ADDENDUM NO. 2

Reference: New Tooele Applied Technology College
Utah College of Applied Technology – Tooele, Utah
DFCM Project No. 11064280

ADDENDUM NO. 2
February 10th, 2012

Tooele Applied Technology College New Building
Tooele, Utah

ME605

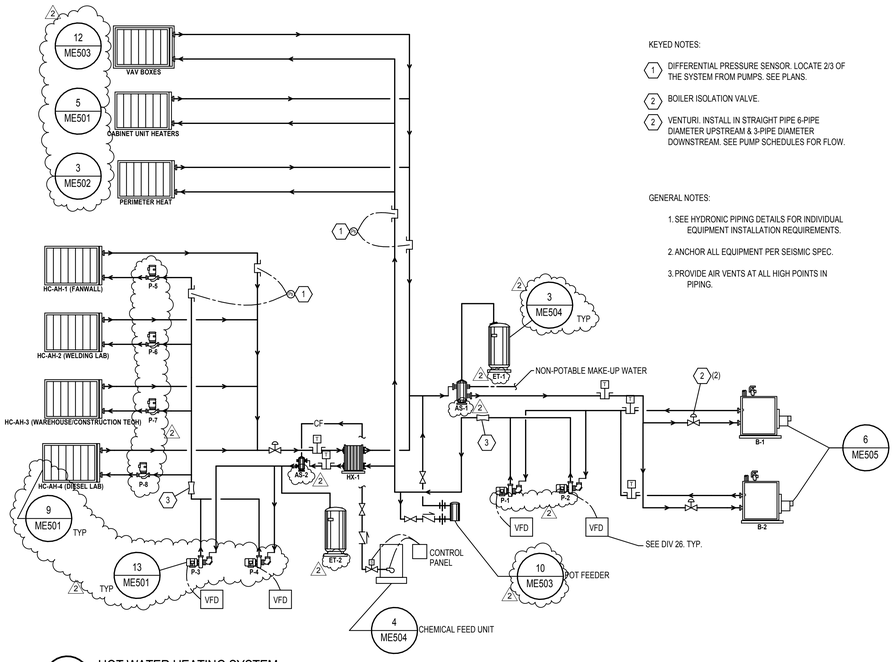
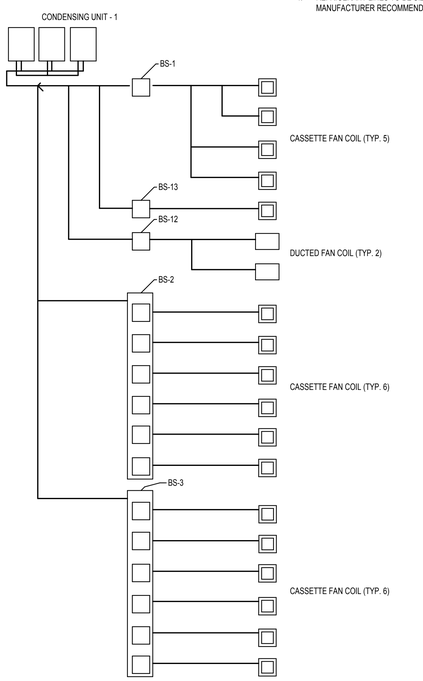
AD2-M11 SHEET - ME605
1. Revise hot water heating system schematic. See attached.

1 Lvl 1 Mechanical Plan 1
SCALE: 1/8" = 1'-0"

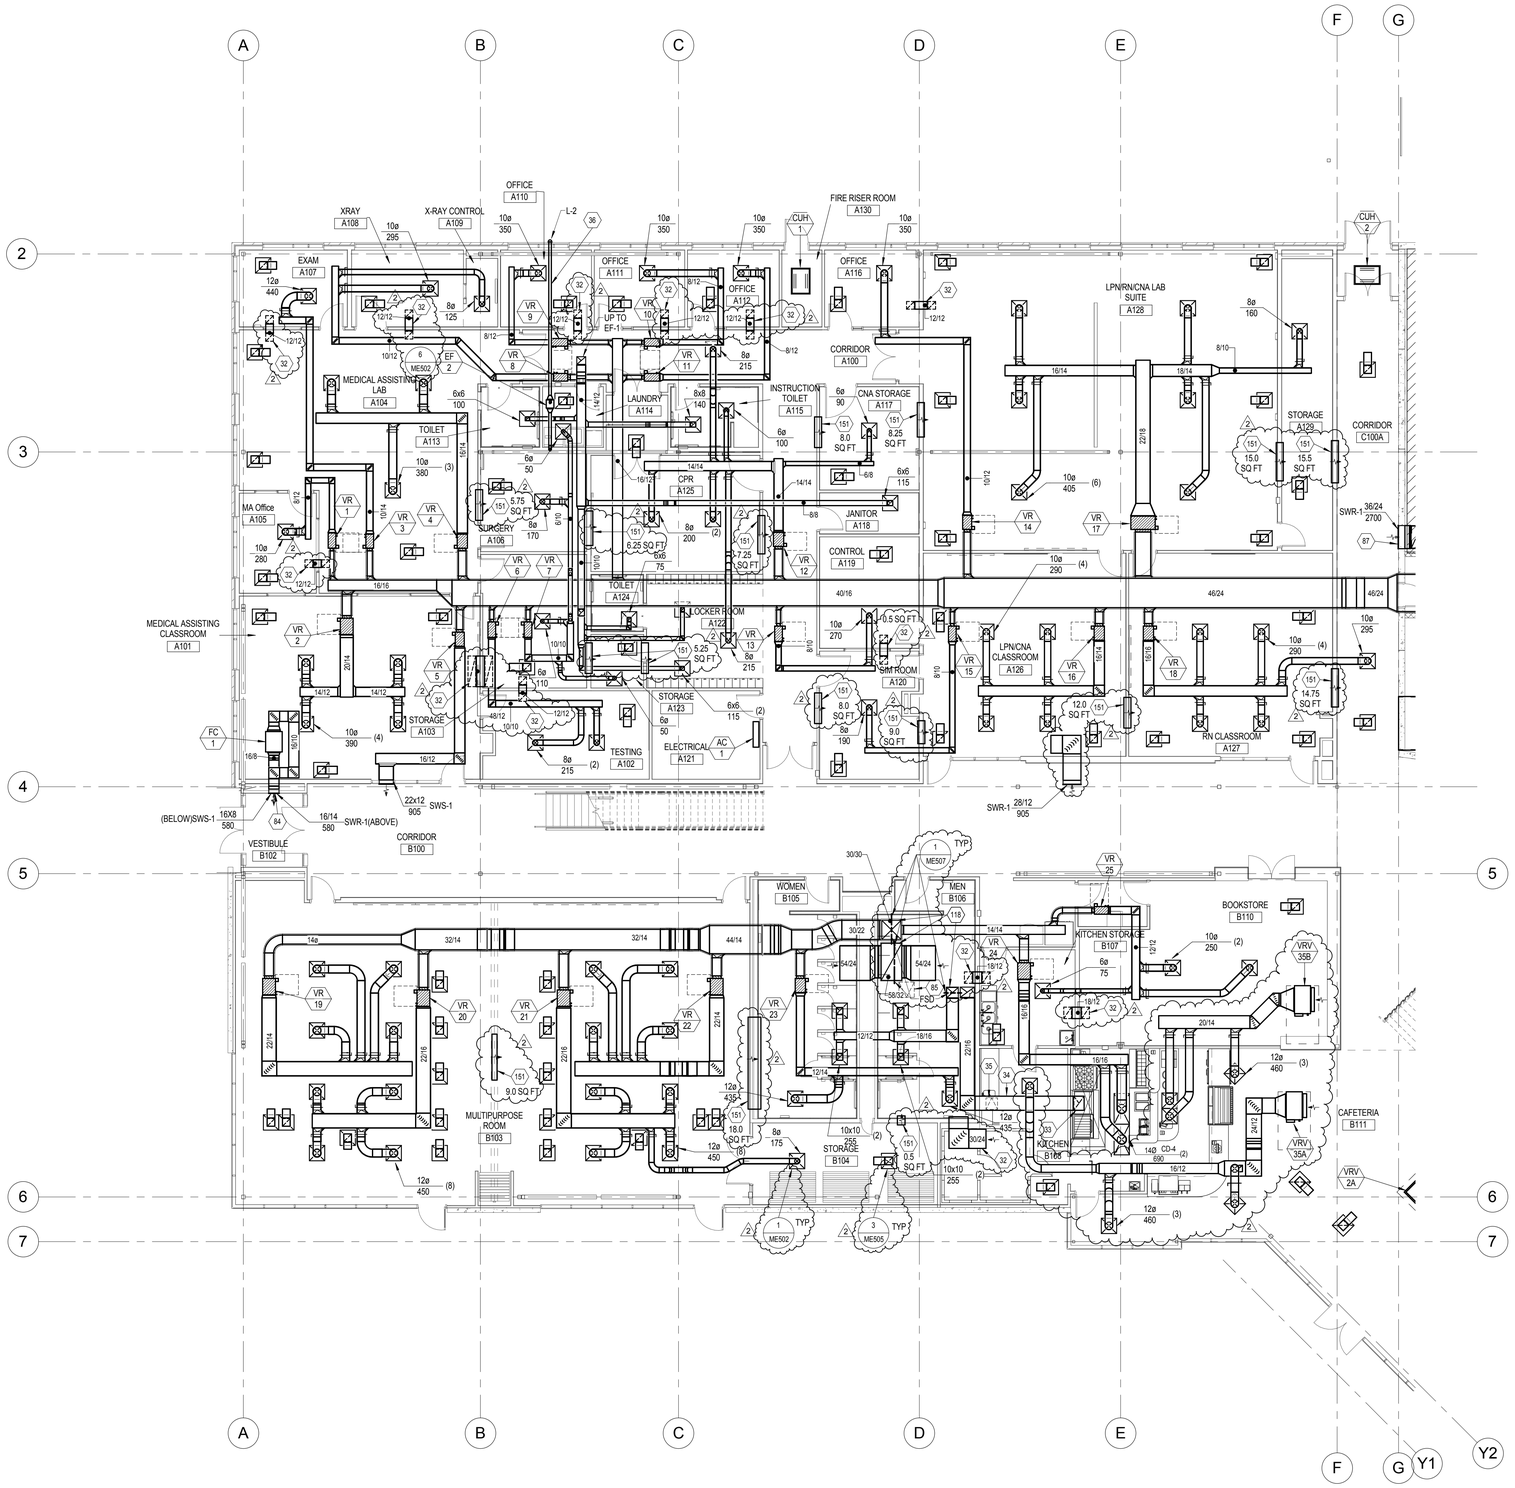
AD2-M12 SHEET - MH111
1. Add return air transfer sound boots and openings in the walls above the ceiling. See attached.
2. Add various detail callouts and notes for clarification. See attached.
3. Add supply ductwork to VRV-35A and VRV-35B as shown. See attached.

1 Lvl 1 Mechanical Plan 2
SCALE: 1/8" = 1'-0"

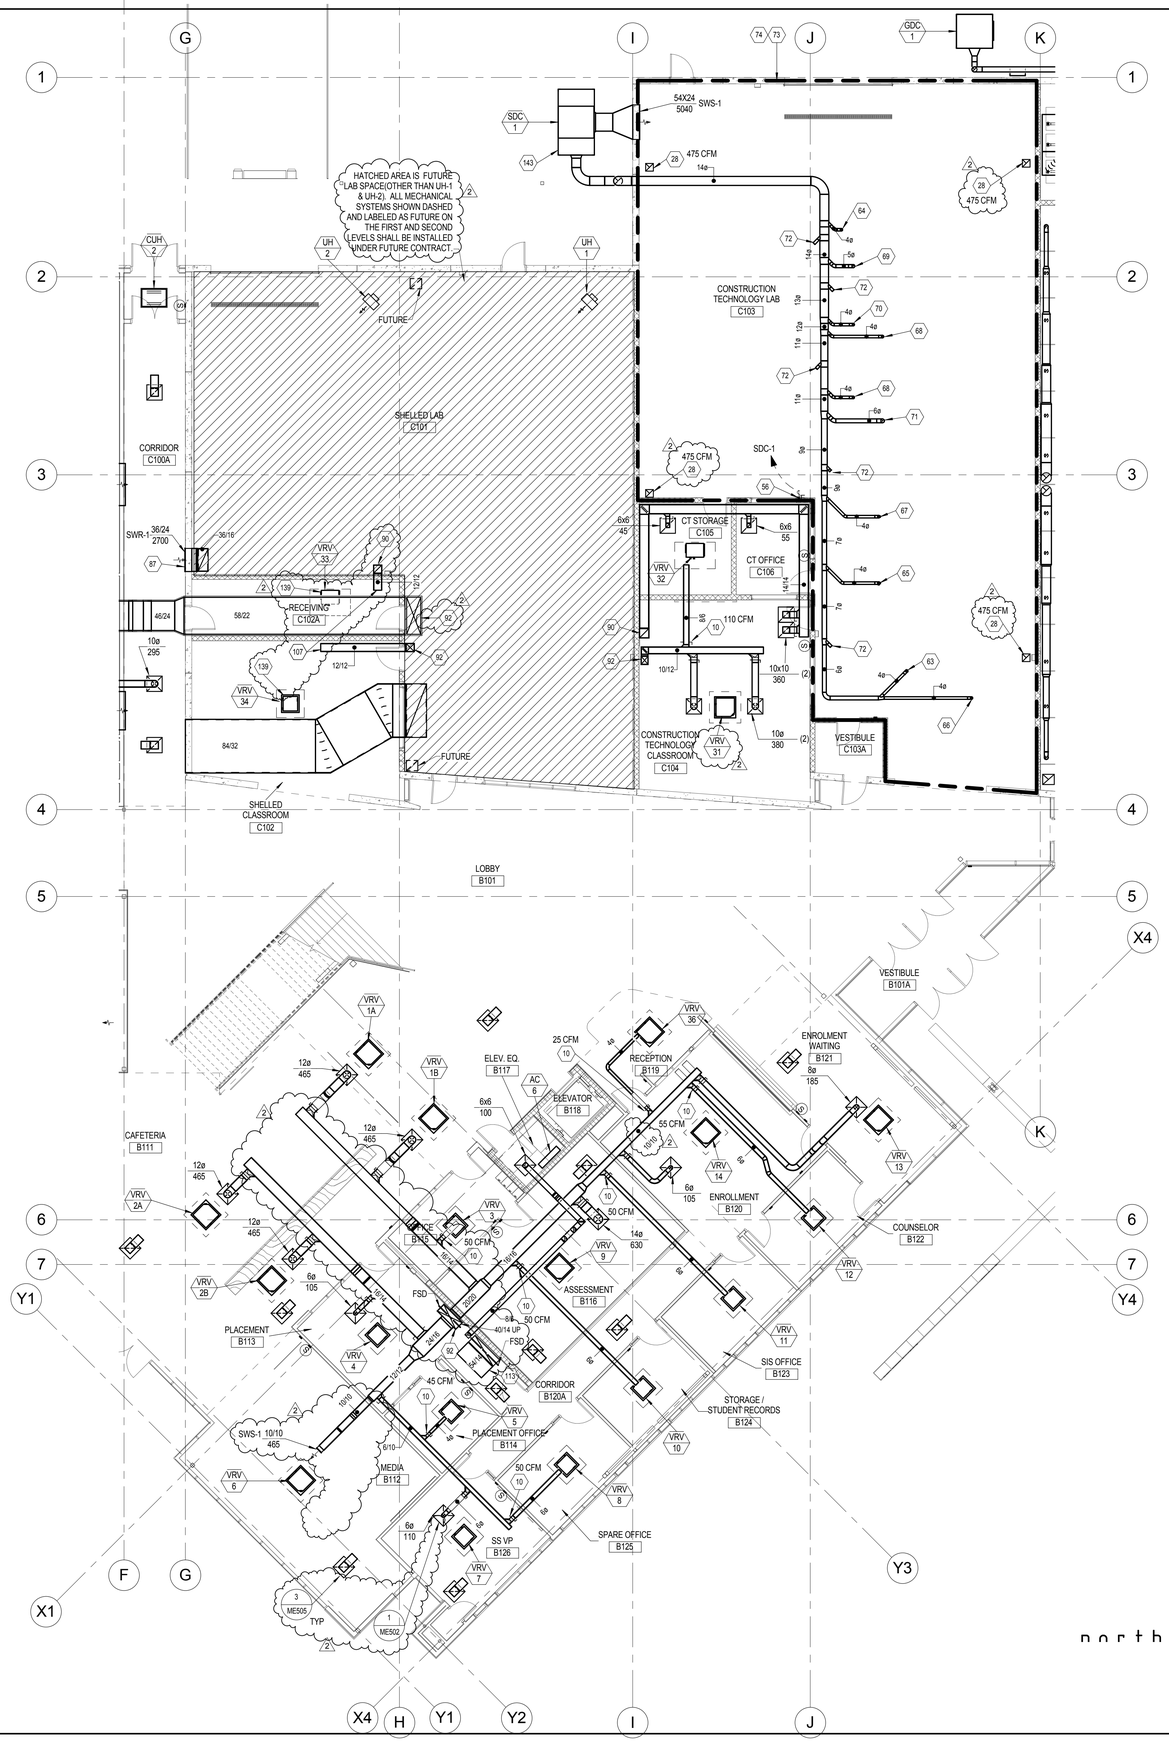
AD2-M13 SHEET - MH112
1. Add notes clarifying what mechanical equipment is to be installed in Shelled Lab C101, Receiving C102A, and Shelled Classroom C102 under the current contract. See attached.
2. Modify duct layout and dimensions of outdoor air duct in cafeteria B111, Media B112, Enrollment B120. See attached.
3. Modify note callouts in Construction Technology Lab and Classroom. See attached

1 Lvl 2 Mechanical Plan 1
SCALE: 1/8" = 1'-0"

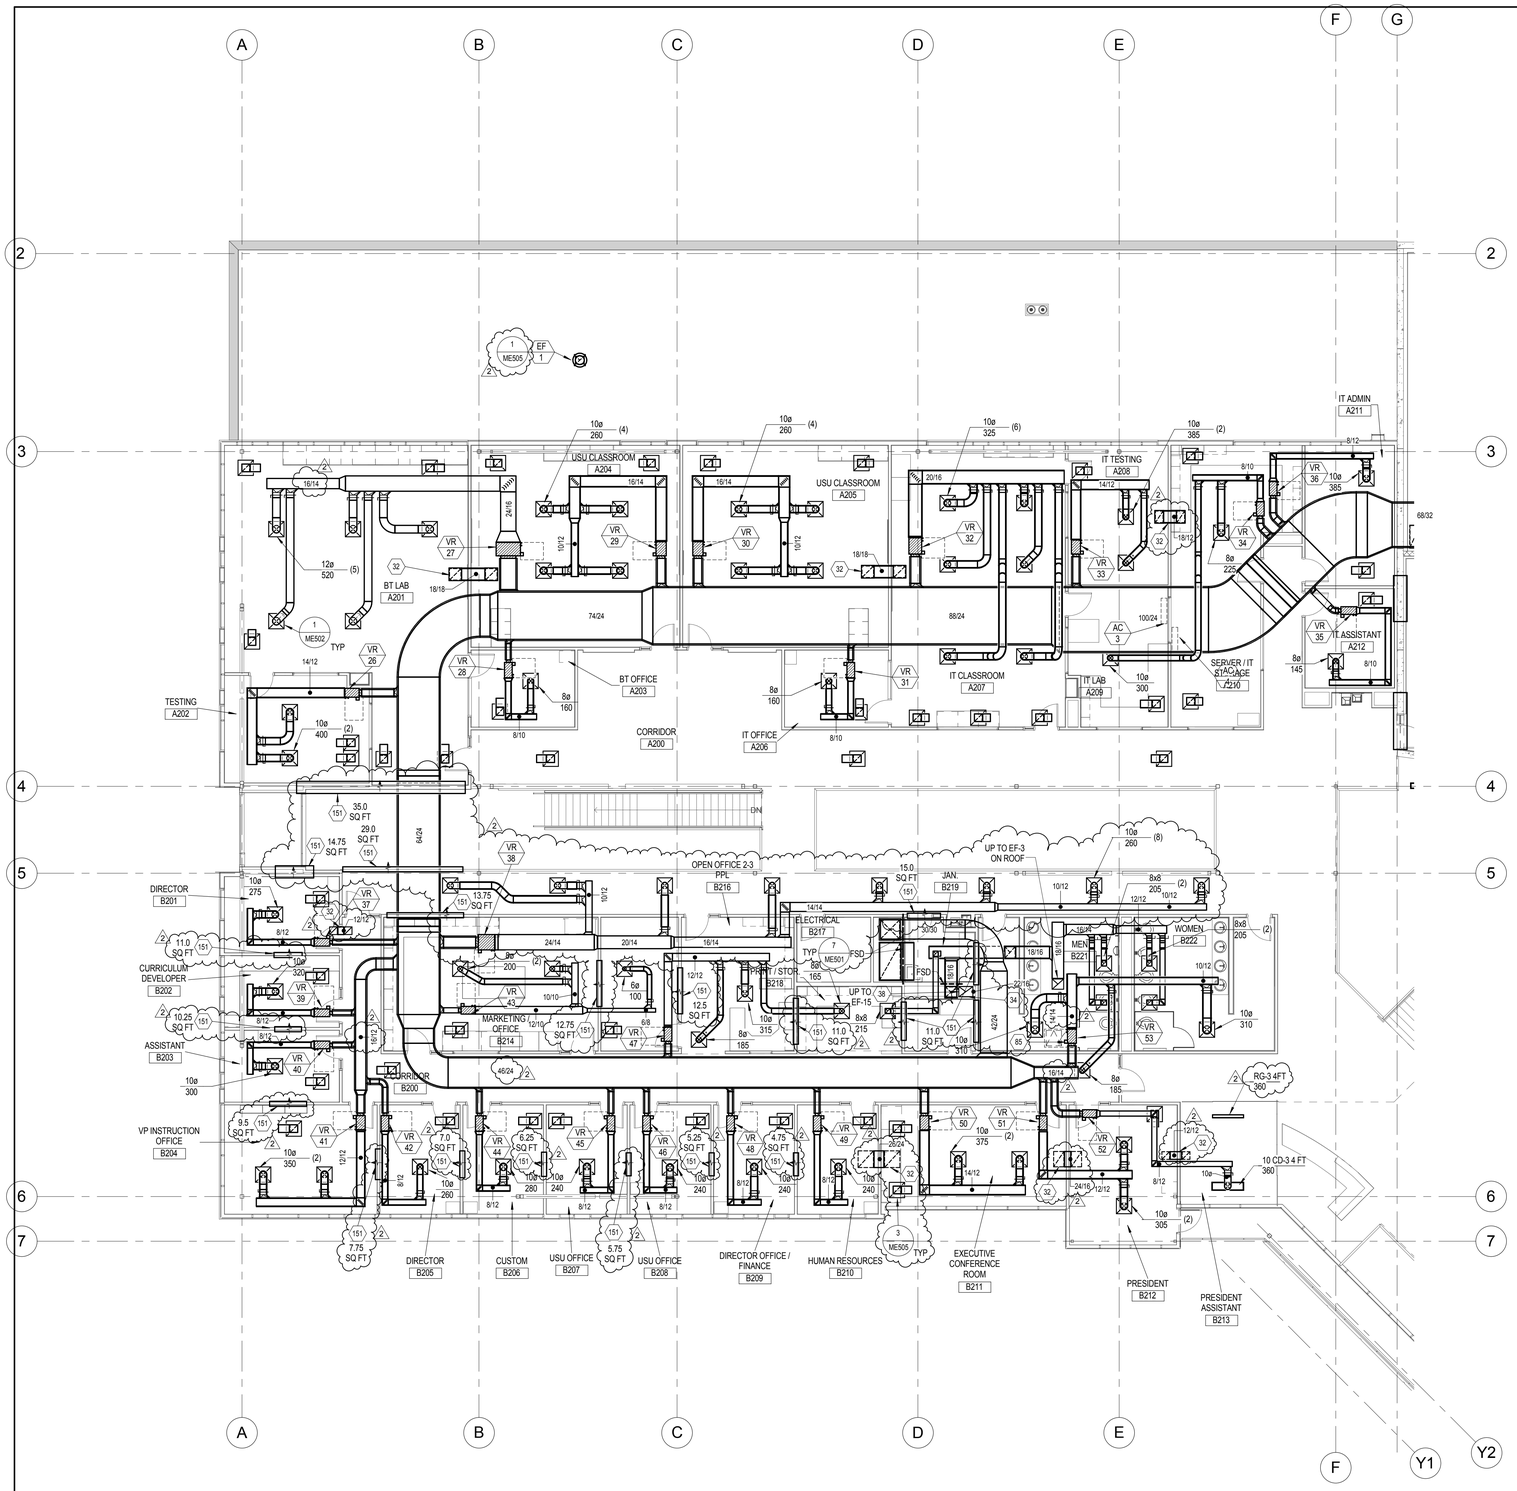
1. Add return air transfer sound boots and openings in the walls above the ceiling. See attached.
2. Add various detail callouts. See attached.

sheet:
PE502

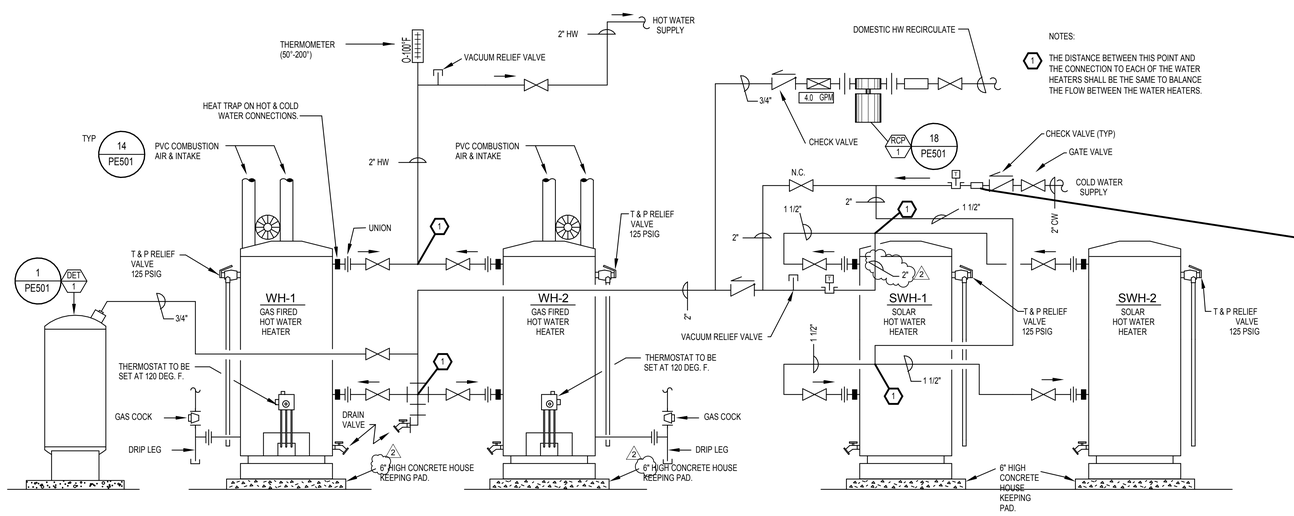
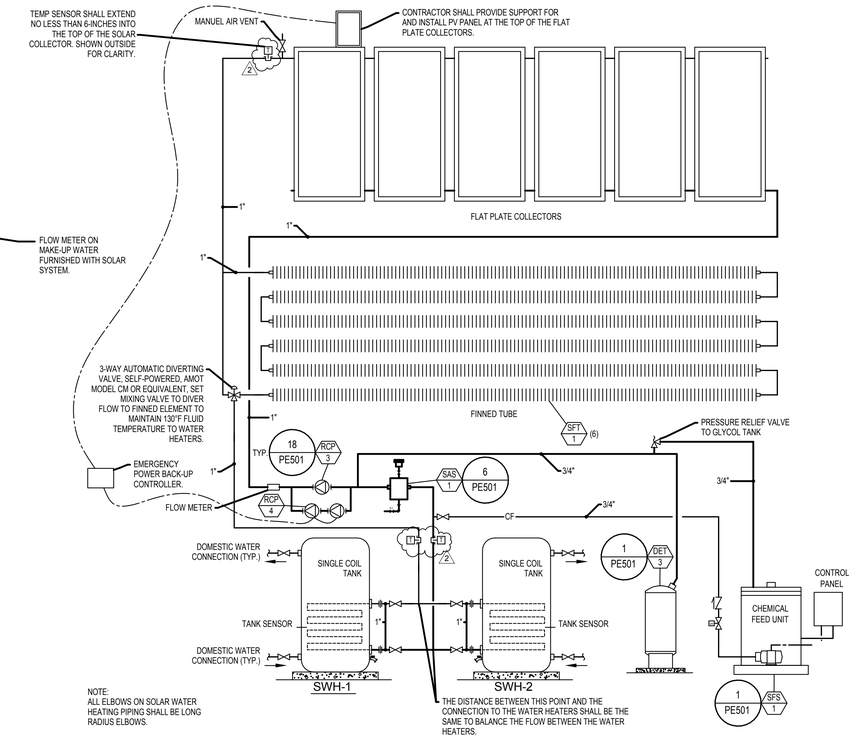
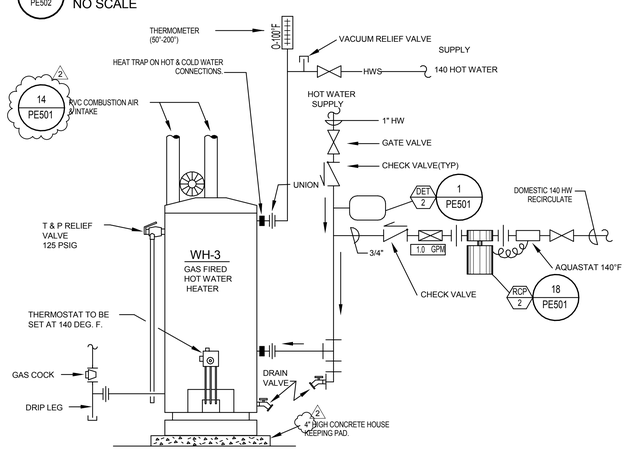
1. Make revisions shown on details 1, 3, 6, and 7. See attached drawing.

1 LEVEL 1 LIGHTING PLAN - AREA '1'

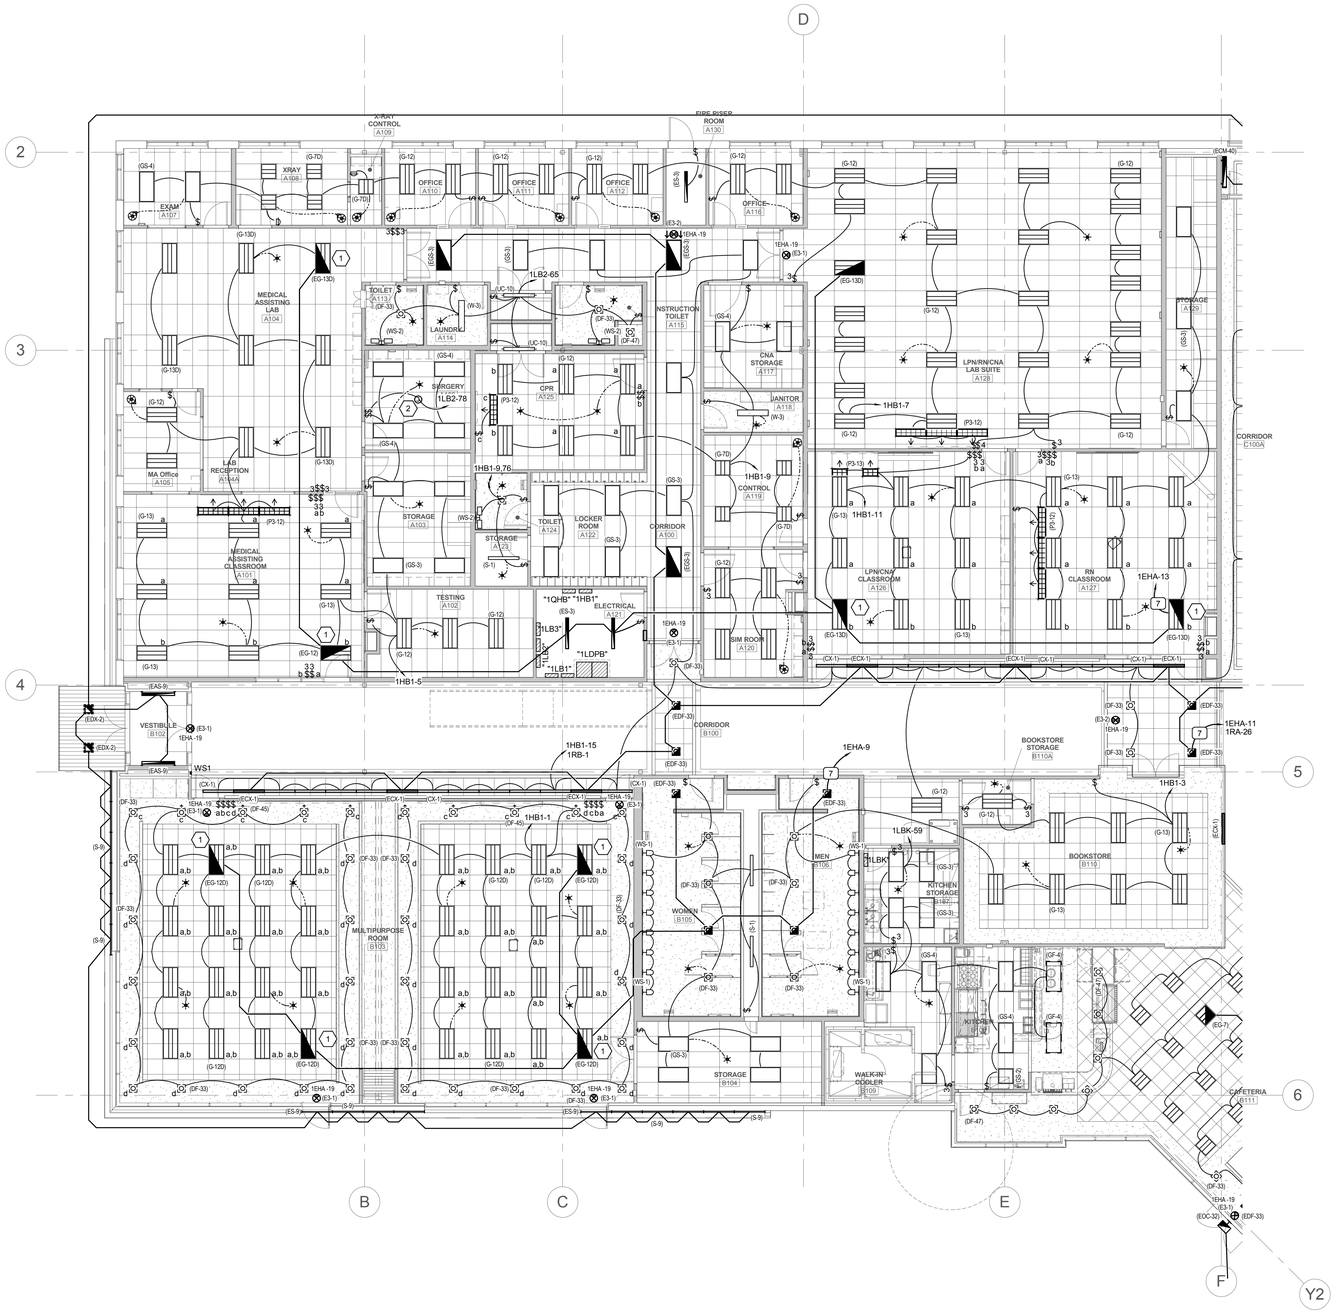
2. Lighting and circuiting has been updated on whole sheet. Refer to attached drawing EL111.
